Virgil C. Summer Nuclear Station (VCSNS) Units 2 and 3
Combined License Nos. NPF-93 and NPF-94
Docket Nos. 52-027 & 52-028

Subject: VCSNS Units 2 & 3 LAR 13-24: Request for License Amendment:
Containment Internal Floor Module Connections

Request for License Amendment:
Containment Internal Floor Module Connections
(LAR 13-24)

Proposed Changes to Licensing Basis Documents
(LAR 13-24)

UFSAR Subsection 3.8.3.5.8.1, Structural Wall Modules - Revise information in the second paragraph, and include the new third paragraph in the location shown below.

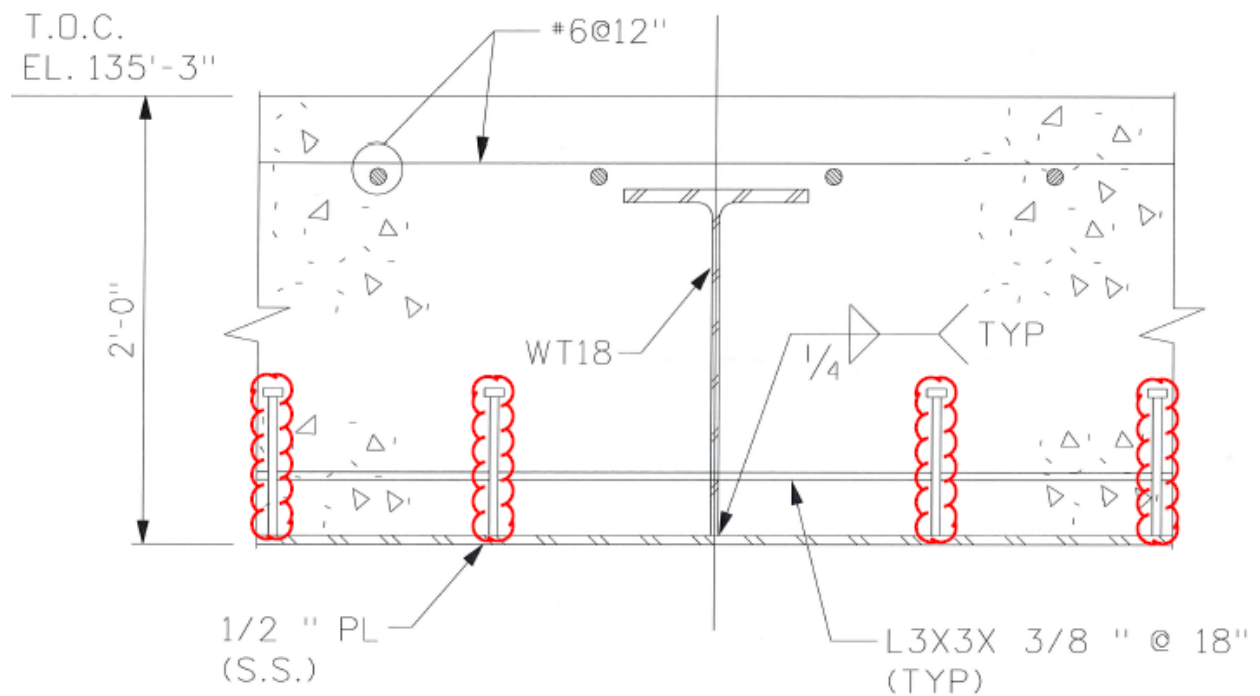
The proposed changes to the second paragraph of UFSAR Subsection 3.8.3.5.8.1 separate the discussion of floor module connections from the wall module discussions. UFSAR Figure 3.8.3-17 is removed from the list of wall module figures. The proposed changes include a revision to note that design elements used in the connections and design details may vary in the implemented design. The proposed changes include adding a sentence in the licensing basis identifying that a key design feature is that design elements provide a direct load path from the floor into the wall. Reference to UFSAR Subsection 3.8.3.1.3 for additional requirements is added to the paragraph. The proposed changes include a revision to note that load capacities of connection design elements satisfy AISC N690 criteria and requirements. Information is also added to reference ACI 349 requirements for reinforcement and standard hooks. Information is added to the description of the floor module connection to include a type of floor where the top of the wall does not extend past the elevation of the floor as a variance to the floor connection designs. Information is added to note that UFSAR Figure 3.8.3-17 is not representative of the connection of the operating deck floor to the walls of the refueling canal and other locations where a floor module rests on top of a structural wall module.

1. Remove UFSAR Figure 3.8.3-17 from the list of figures showing wall module information.
 2. Move the sentence describing the floor module connections to be the first sentence of a newly created separate paragraph.

3. Enhance the discussion of the information in UFSAR Figure 3.8.3-17 as part of the new separate paragraph.
 4. Identify that the design elements used and the connection design details vary.

5. Describe direct load path as a key feature in connection design.
 6. Add reference to additional information on the connection design in UFSAR Subsection 3.8.3.1.3.

7. Identify that details of the connection design including plate thickness, structural shape size, and reinforcement arrangement may vary based on local loads.

8. Specify that the connection design must provide sufficient load capacity to satisfy AISC N690 and ACI 349 criteria and requirements.
 9. Add information to note that UFSAR Figure 3.8.3-17 is not representative of the connection of the operating deck floor to the walls of the refueling canal and other floor modules that rest on structural wall modules.

[The details shown in Figure 3.8.3-17 are representative of connections between floors in containment and walls constructed using steel plate concrete composite construction.]* The design details for the floor module are provided for background information and vary based on loading conditions and geometry. The seat angles, beam seats, clip angles, shear plates, shear studs, and reinforcement bars shown in Figure 3.8.3-17 and other design elements are used as required for the connection. A key feature of the connection design is that the design elements provide a direct load path from the floor into the wall. Additional information on the connection design is provided in Subsection 3.8.3.1.3. Details of the connection design, including plate thickness, structural shape type and size, use of specific design elements, and reinforcement arrangement, vary based on local loads. The design implemented in fabrication and construction drawings and instructions may have alternative structural shapes or reinforcement arrangements if they provide sufficient load capacity to satisfy AISC N690 and ACI 349 criteria and requirements. Figure 3.8.3-17 is not representative of the connection between the operating deck floor and the wall modules that form the sides of the refueling canal because these walls do not extend above the floor and the major connection design elements are located within the thickness of the wall and not attached to the faceplates.

UFSAR Section 3.8, Figure 3.8.3-3, Structural Floor Module - Revise information for the structural floor module as shown below.

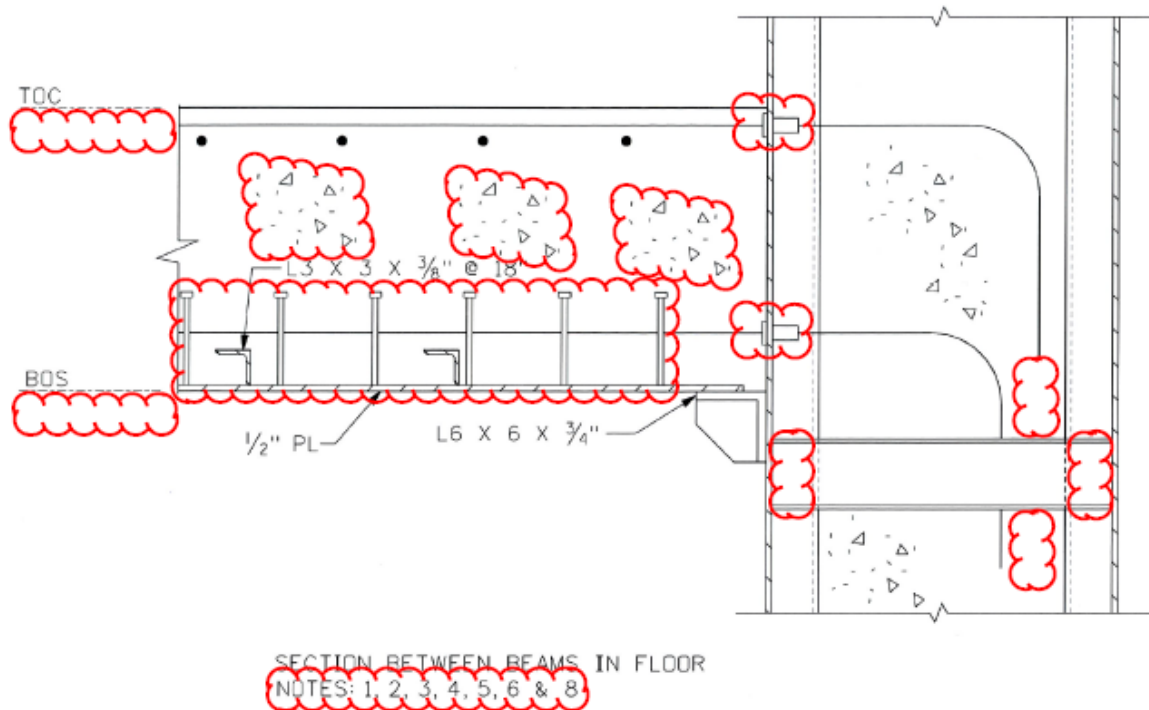
UFSAR Figure 3.8.3-3 shows the floor module design and is revised to include the shear studs attached to the bottom steel plate of the module.

- D. Revise UFSAR Figure 3.8.3-3 to add shear studs on top of the bottom steel plate of the floor module.

Revising the information in UFSAR Subsection 3.8.3.1.4 to add shear studs and channels to the list of design elements used to construct the floor modules and adding shear studs to UFSAR Figure 3.8.3-3 expands the range of design elements used in the construction of the floors. The use of shear studs and channels in the design of the floor is consistent with the applicable requirements of AISC N690 and the design requirements and evaluation methods described in UFSAR Subsection 3.8.3.5.4. The use of shear studs and channels in the design of the floor is included in the evaluation of the floor module and connection design.

UFSAR Section 3.8, Figure 3.8.3-17, Sheet 1 of 2 [*Structural Modules –Design Details Standard Floor Connection*]* - Revise information for the SECTION BETWEEN BEAMS IN FLOOR as shown below.

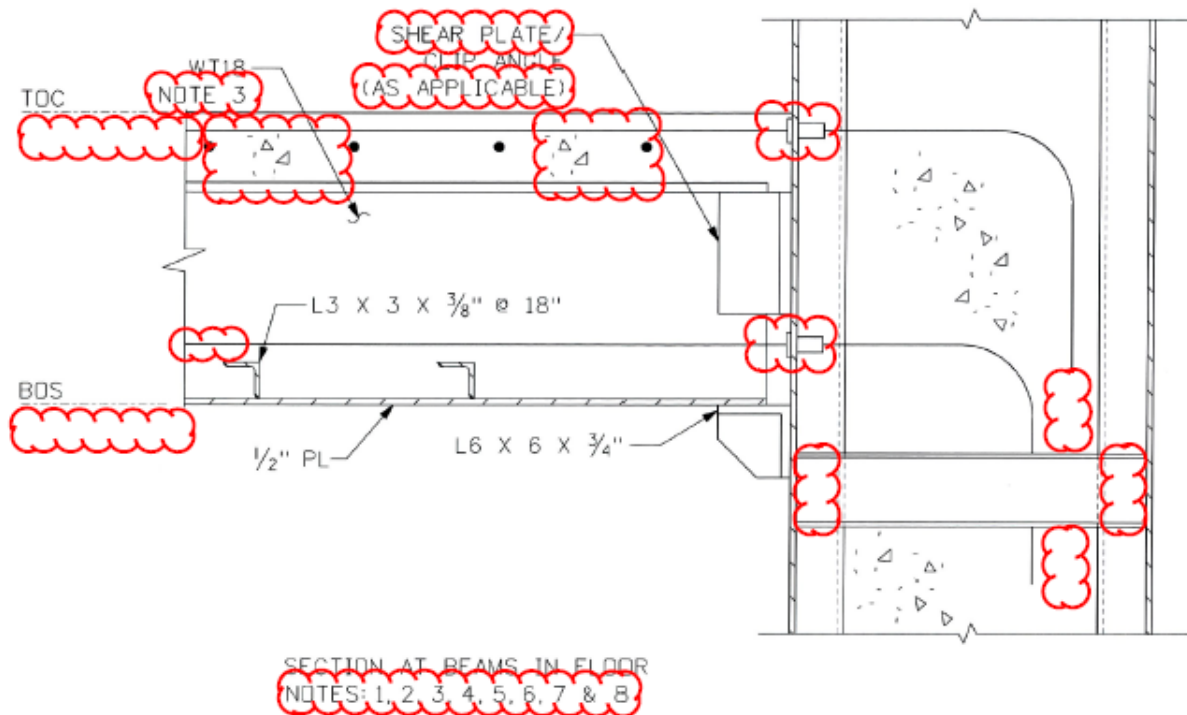
There are proposed changes in the design of the structural wall module faceplate connection with the floor modules shown in UFSAR Figure 3.8.3-17, Sheet 1. The figure shows seat angles welded to the vertical face of structural wall modules under the ends of the floor modules with a clip angle connecting the floor module beam to the wall module. The proposed design changes remove the requirement to use these clip angles and include the use of shear plates as a design variation. Notes are added to the figure to identify variation in the connection design. The proposed changes revise the representation of the truss channels to extend to the inside surface of the faceplates. The figure is also revised to remove the elevations for top of concrete (TOC) and bottom of steel (BOS) on Sheet 1 and Sheet 2 because the wall module to floor module connection designs are used at more than one floor elevation. The representation of the reinforcement hooks length is changed to be consistent with the ACI standard for standard hooks. The representation of reinforcement connector on the faceplate is changed to be consistent with the type of connector used.

3. Add “SHEAR PLATE” and the term “(AS APPLICABLE)” to the clip angle designation where shown on Sheet 1 and Sheet 2. Revise the figure to show a clip angle and a shear plate instead of two clip angles in the connection in Sheet 2, TOP VIEW AT BEAMS IN FLOOR and in Section A.

5. Redraw reinforcement hooks to show proper length for standard hooks in both sections on Sheet 1 and in SECTION BETWEEN BEAMS IN FLOOR on Sheet 2.
 6. Change representation of reinforcement connector on faceplate to show representative configuration of the connector in both sections on Sheet 1 and in SECTION BETWEEN BEAMS IN FLOOR on Sheet 2.

14. Remove symbols indicating concrete from Sheet 2 SECTION AT BEAMS IN FLOOR and add the symbols indicating concrete to Sheet 2 SECTION BETWEEN BEAMS IN FLOOR and Sheet 1 SECTION BETWEEN BEAMS IN FLOOR to be consistent with the materials at those locations.

17. Add designation of reinforcement bar size (#11) to Sheet 2 SECTION BETWEEN BEAMS IN FLOOR.
18. Add shear studs attached to the bottom steel plate of the floor module in SECTION BETWEEN BEAMS IN FLOOR in Sheet 1 and 2.

UFSAR Section 3.8, Figure 3.8.3-17, Sheet 1 of 2 [Structural Modules –Design Details Standard Floor Connection]* - Revise information to add Notes as shown below.

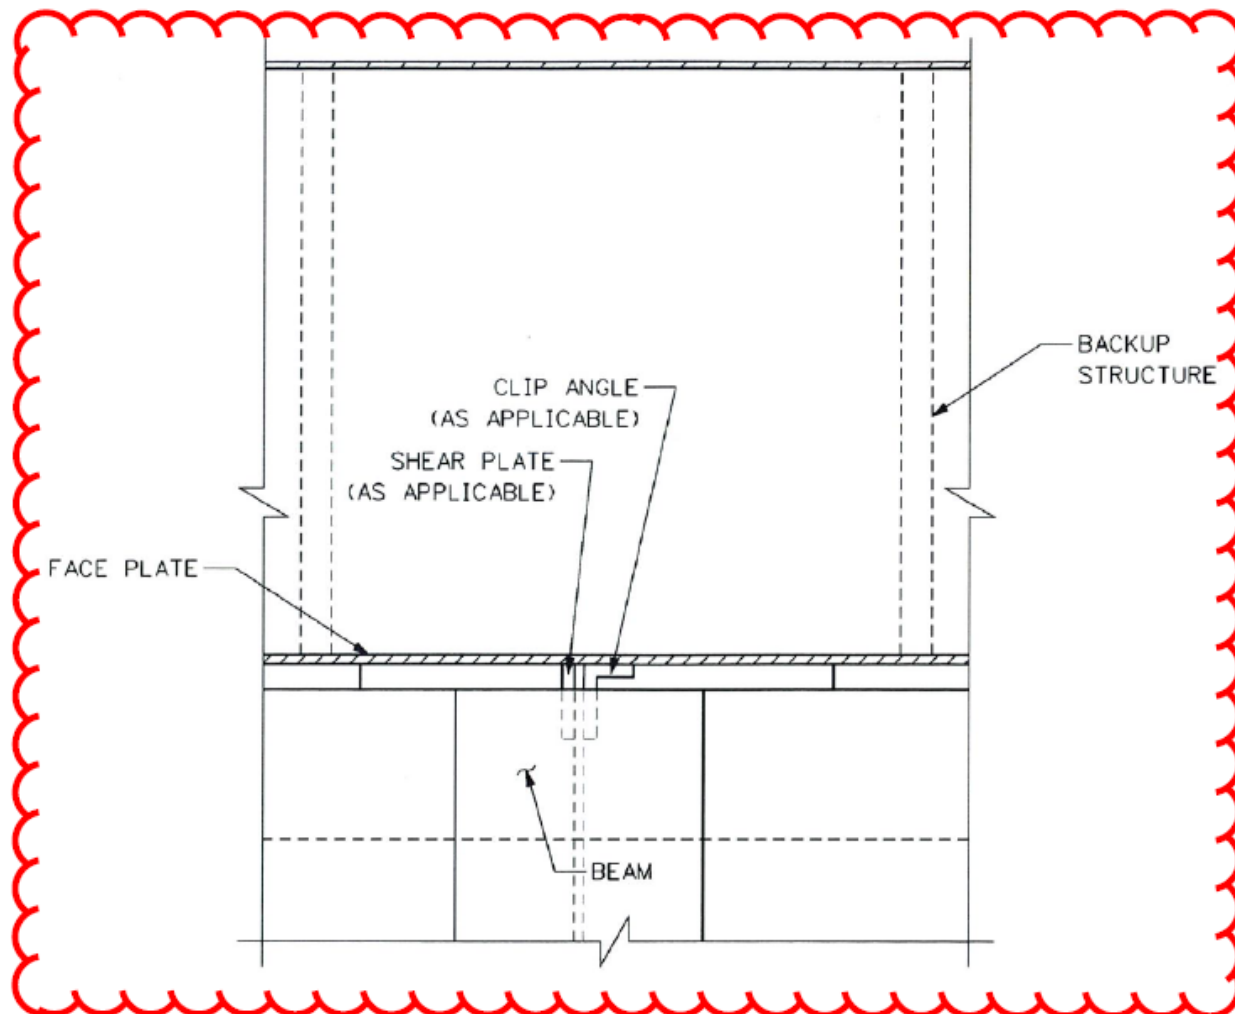
19. Add notes to UFSAR Figure 3.8.3-17, Sheets 1 and 2 to provide the following information:
 - a) Identify that details shown are representative of floor modules at El. 107'-2" and 135'-3" and the connections of floor modules to wall modules inside containment. Include reference to Subsection 3.8.3.1.3 and other notes for additional information about design details and variations.

1. DETAILS SHOWN ARE REPRESENTATIVE OF FLOOR MODULES AT EL 107'-2" AND 135'-3" AND THE CONNECTIONS OF FLOOR MODULES TO WALL MODULES INSIDE CONTAINMENT. REFER TO SUBSECTION 3.8.3.1.3 AND OTHER NOTES FOR ADDITIONAL INFORMATION ABOUT DESIGN DETAILS AND VARIATIONS FOR FLOOR MODULE TO WALL MODULE CONNECTIONS. DETAILS ARE NOT REPRESENTATIVE OF THE CONNECTION BETWEEN THE OPERATING DECK FLOOR AND THE WALL MODULES THAT FORM THE SIDES OF THE REFUELING CANAL; SEE SUBSECTION 3.8.3.5.8.1.

2. REINFORCEMENT USE, SIZE, AND SPACING IN THE FLOOR MODULE CONCRETE SATISFY THE REQUIREMENTS IN ACI 349. THE REINFORCEMENT SIZE RANGE IS #7 TO #11.
3. DESIGN OF THE PLATES, BEAMS, AND STIFFENERS IN THE FLOOR, INCLUDING PLATE SIZE AND SPACING, AND TYPE, SIZE, AND SPACING OF STRUCTURAL SHAPES VARIES AND SATISFIES THE REQUIREMENTS OF AISC N690.

4. THE REINFORCEMENT AND FLOOR DESIGN ELEMENTS SHOWN ARE FOR LOCATIONS AWAY FROM OPENINGS, PENETRATIONS, AND OTHER OBSTRUCTIONS.
5. WHERE REINFORCEMENT IS INCLUDED AS PART OF THE CONNECTION DESIGN, THE SIZE, SPACING, AND LENGTH SATISFY THE REQUIREMENTS OF ACI 349. THE DESIGN OF THE STANDARD HOOKS IN THE WALL MODULES AND THE COUPLERS CONNECTING THE FLOOR REINFORCEMENT TO THE HOOKS IN THE WALL MODULES SATISFIES THE REQUIREMENTS OF ACI 349.

6. THE DETAIL DESIGN, LOCATION, AND ATTACHMENT OF THE FLOOR AND BEAM SUPPORTS ARE DESIGNED TO THE REQUIREMENTS OF AISC N690. SUPPORT CONFIGURATIONS, INCLUDING THE USE OF PLATES, STRUCTURAL SHAPES, AND STIFFENERS, ARE BASED ON LOADING AND LOCAL GEOMETRY CONSIDERATIONS.

7. THE DESIGNS OF THE CONNECTIONS AND BACKUP STRUCTURES WITHIN THE MODULES WALL, INCLUDING PLATE SIZE AND SPACING, TYPE, SIZE, AND SPACING OF STRUCTURAL SHAPES, AND USE, SIZE, AND SPACING OF SHEAR STUDS VARY AND SATISFY THE REQUIREMENTS OF AISC N690. THE STRENGTH OF THE STUDS IS BASED ON ACI 349 APPENDIX B.

8. THE THICKNESS OF THE ADJACENT WALL IS BASED ON THE WALL DESIGN REQUIREMENTS AND LOCATION.

UFSAR Section 3.8, Figure 3.8.3-17, Sheet 2 of 2 [*Structural Modules –Design Details Heavily Loaded Floor Connection*]* - Revise information for the TOP VIEW AT BEAMS IN FLOOR as shown below.

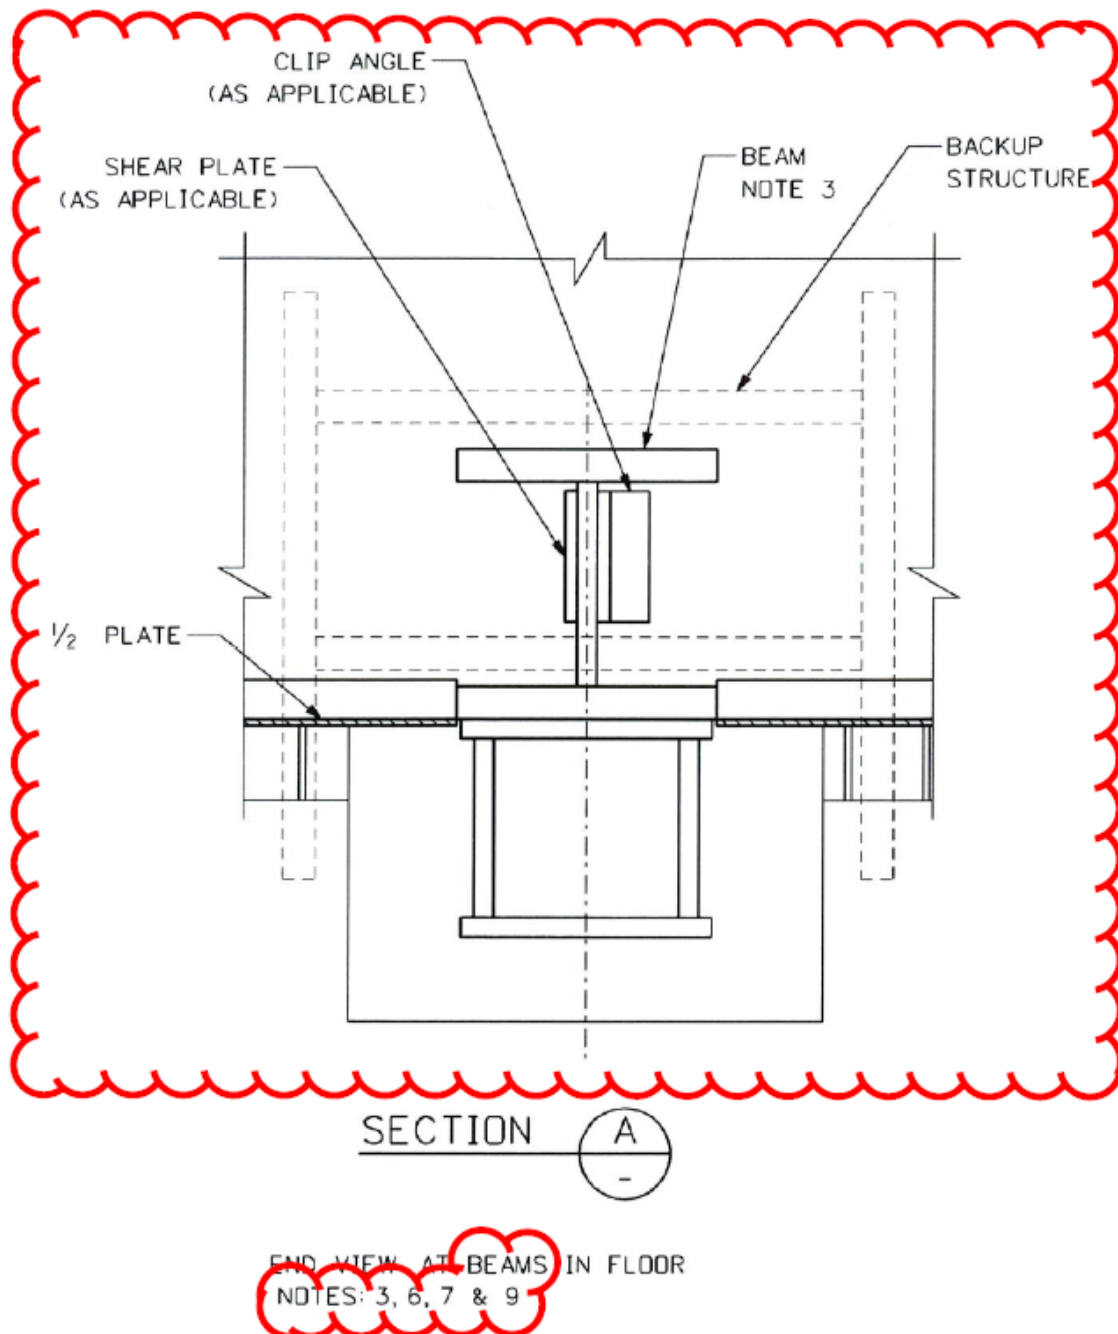
4. Redraw Section A and “TOP VIEW AT BEAMS IN FLOOR” on Sheet 2 to show connection design based on design finalization. The changes remove the reinforcement adjacent to the beam section and remove the connectors adjacent to the beam in Section A.

7. Remove the dimensions from the wall module internal structure and from the plate thickness of backup structure from Top View on Sheet 2.
 8. Redraw the representation of the wall module internal channels to extend to the faceplate in both sections on Sheet 1 and in SECTION AT BEAMS IN FLOOR and SECTION BETWEEN BEAMS IN FLOOR on Sheet 2.

9. Redraw the representation of the backup structure in Top View, SECTION AT BEAMS IN FLOOR, and Section A on Sheet 2.
 10. Redraw the representation of the wall module structure on Sheet 2 to move and reconfigure the plates applied or overlaid onto the faceplates on the connection side of the wall module in TOP VIEW AT BEAMS IN FLOOR, SECTION AT BEAMS IN FLOOR and SECTION BETWEEN BEAMS IN FLOOR.

11. Remove the reinforcement bars in the floor and the reinforcement connectors in the Top View, Section A, and in the SECTION AT BEAMS IN FLOOR on Sheet 2.

UFSAR Section 3.8, Figure 3.8.3-17, Sheet 2 of 2 [Structural Modules – Design Details Heavily Loaded Floor Connection]* - Revise information for the END VIEW AT BEAMS IN FLOOR as shown below.

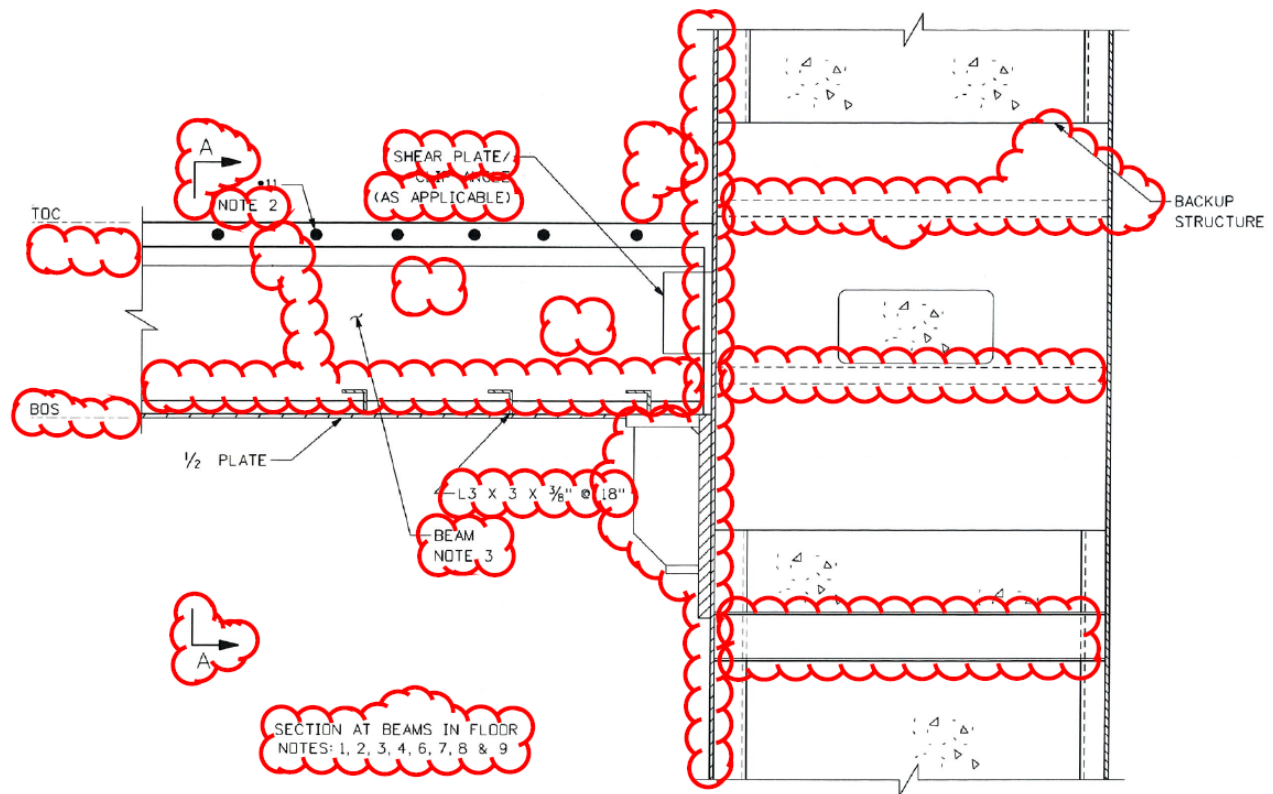
1. Replace the term “Plate Girder” with “Beams” in the Labels for the section views shown on Sheet 2.
 2. Replace the identifier “PLATE GIRDER” with “BEAMS” in three of the section views on Sheet 2.

UFSAR Section 3.8, Figure 3.8.3-17, Sheet 2 of 2 [Structural Modules – Design Details Heavily Loaded Floor Connection]* - Revise information for the SECTION AT BEAMS IN FLOOR as shown below.

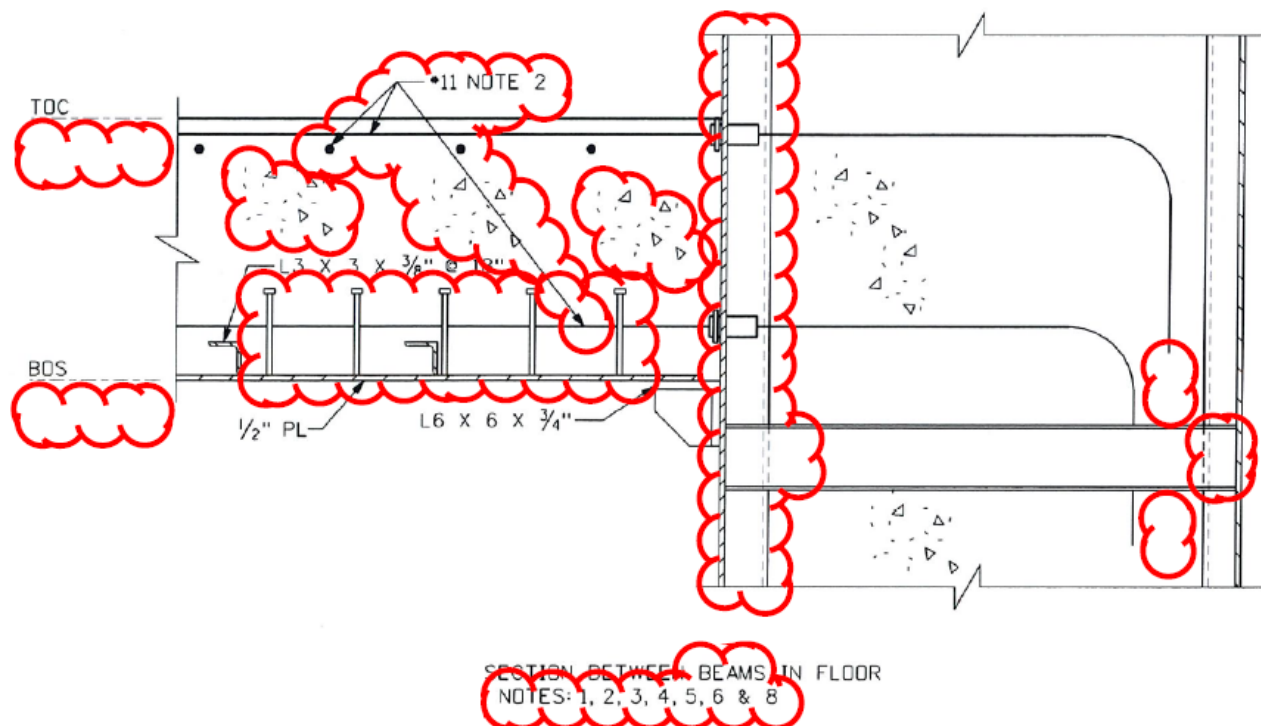
The proposed changes in the design of heavily loaded floor modules, shown in UFSAR Figure 3.8.3-17, Sheet 2, are representative for "heavily loaded" floor connections. The figure shows two clip angles for the beam connection to a structural wall module. The proposed design changes reconfigure the connection, add the use of shear plates, and remove one of the clip angles shown for the connection. At the beam location the seat angle supporting the beam is changed to show a beam seat. The changes reconfigure the backup structure and remove the plate thickness for the back-up structure because there is a large variation in the detail design of the internal backup structures. The sizes of the angle and channel that are part of the truss in the wall modules are removed because this information is included in Figure 3.8.3-8. The backup structure shown in the module wall is a representative design for the connection and the details for the design implemented may vary from that shown in the figure. The

changes to the figure remove reinforcement bars at the beam locations connected to the faceplates and the associated hooks within the wall modules. In some locations, reinforcement bars connected to the wall module are not provided immediately adjacent to the beam. Consistent with Note 5 added to the figure, where reinforcement is used, the size, spacing, and length satisfy ACI 349 requirements. Symbols identifying the location of Section A and representing concrete are moved on the figure to clarify the design. Dimensions of structural angles and reinforcement bars are added and moved on the figure due to removal of this information in other portions of the figure. Use of the term "plate girder" is replaced with "beam" on UFSAR Figure 3.8.3-17, Sheet 2. This is consistent with the use of the term "beam" on Sheet 1 of the figure.

12. Remove the elevations for TOC (top of concrete) and BOS (bottom of steel) on Sheet 1 and Sheet 2.
 13. Move arrows identifying Section A in SECTION AT BEAMS IN FLOOR on Sheet 2 to clarify the location of Section A.

15. Add the dimensions for the angles welded to the floor in Sheet 2, SECTION AT BEAMS IN FLOOR.
16. Replace the seat angle with a beam seat in Sheet 2, SECTION AT BEAMS IN FLOOR.

8. THE THICKNESS OF THE ADJACENT WALL IS BASED ON THE WALL DESIGN REQUIREMENTS AND LOCATION.
9. THE BEAM SEAT SHOWN IS NOT USED AT ALL BEAM LOCATIONS. THE SEAT ANGLE SHOWN ON SHEET 1 IS USED AT OTHER LOCATIONS.
